UNITED STATES PATENT AND TRADEMARK OFFICE

APPLICATION NO.	FILING DATE	FIRST NAMED INVENTOR	ATTORNEY DOCKET NO.	CONFIRMATION NO.
10/624,338	07/22/2003	Clayton M. Grondahl	GRON-0002	6985
23550 7590 07/16/2007 HOFFMAN WARNICK & D'ALESSANDRO, LLC 75 STATE STREET 14TH FLOOR ALBANY, NY 12207			EXAMINER REESE, DAVID C	
			ART UNIT 3677	PAPER NUMBER
			MAIL DATE 07/16/2007	DELIVERY MODE PAPER

Office Action Summary	Application No.		Applicant(s)	
	10/624,338		GRONDAHL, CLAYTON M.	
	Examiner		Art Unit	
	David C. Reese		3677

DETAILED ACTION

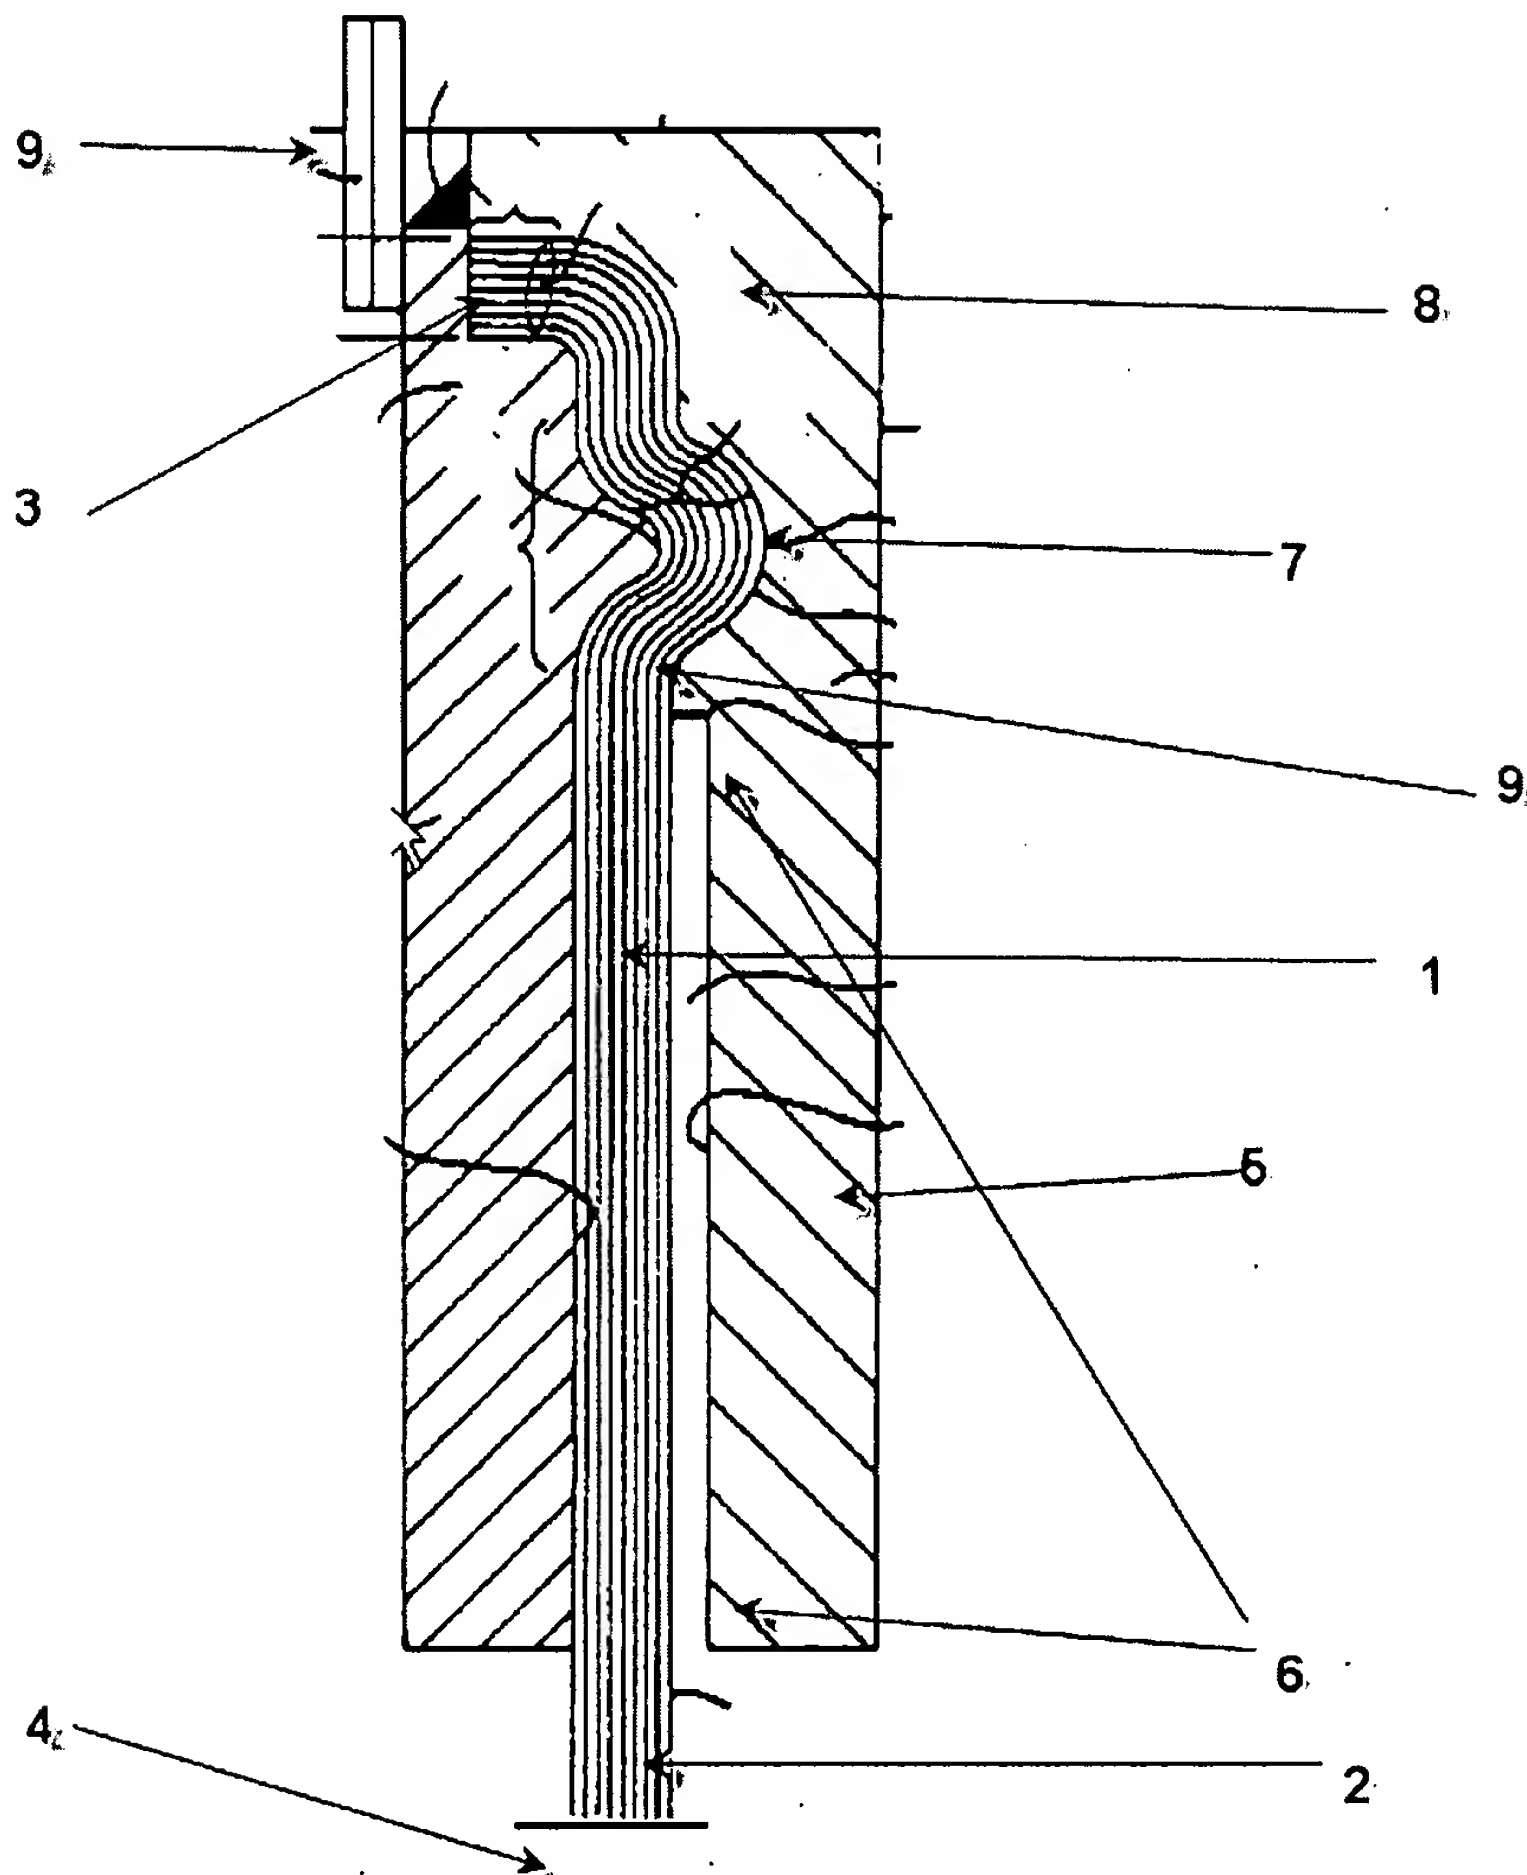
With respect to claims 1, 9, 19, and 24, Gail discloses of a seal assembly (see figure below) comprising:

a brush seal (1) with a plurality of staggered seal members, each brush seal member including:

a free portion (2) [adapted to be] angled relative to a longitudinal axis and all radial axes of a component (4) to be sealed against; and

a fixed portion (3) that is angled relative to free portion (2) and adapted to be one of substantially parallel to and substantially perpendicular to the longitudinal axis of the component (4) to be sealed against; and

a support (5) coupled to a low pressure side of the seal for supporting the free portion (2), the support (5) having a support portion facing a high pressure side of the seal,

wherein the free portion (2) contacts a distal end (6) in an pressurized operative state (col. 5, lines 18-36, “...are elastically deflectable in the circumferential direction and to a limited

extent also in the axial direction...while running”) and is out of contact with the distal end (6) in an unpressurized inoperative state (Fig. 1), the fixed portion (3) of the seal is angled relative to the free portion (2) in both the operative and inoperative states, and the free portion (2) is adapted to be closer to the component (4) to be sealed against during the pressurized operative state than in the unpressurized inoperative state (col. 5, lines 18-36, “...are elastically deflectable in the circumferential direction and to a limited extent also in the axial direction...while running motion of rotor”):

Re: Claim 3, wherein the support portion (5) includes a curved surface (7) extending from a proximate end (8) of the support portion (5) to the distal end (6), and the free portion (2) extends tangentially (9) from the curved surface in the operative state.

Re: Claim 4, wherein the proximate end (8) is coupled to a mount portion (9) of the support that mounts the support (5) to a stationary component.

Re: Claim 8, wherein the fixed portion (3) is positioned substantially perpendicular to a longitudinal axis of a component (4) to be sealed, and the free portion (2) is angled out-of-plane relative to the fixed portion (3).

Re: Claim 11, wherein the distal end (6) of the support (5) portion is thinner than a proximate end (8) of the support portion, and the proximate end (8) is in contact with the free portion in the inoperative state (at 9).

Re: Claim 12, wherein the support portion (5) includes a curved surface (7) extending from a proximate end (8) to the distal end (6).

Re: Claim 13, wherein the proximate end (8) is coupled to a mount portion (9) of the support that mounts the support (5) to a stationary component.

Re: Claim 15, further comprising a holder for mounting the seal assembly to a stationary component, wherein the holder includes a projection for protecting the free portion (see area below and around 8 in the figure above).

Re: Claim 21, wherein the support portion (5) includes a curved surface (7) extending from a proximate end (8) to the distal end (6).

Re: Claim 23, wherein the fixed portion (3) is positioned substantially perpendicular to a longitudinal axis of a component (4) to be sealed, and the free portion (2) is angled out-of-plane relative to the fixed portion (3).
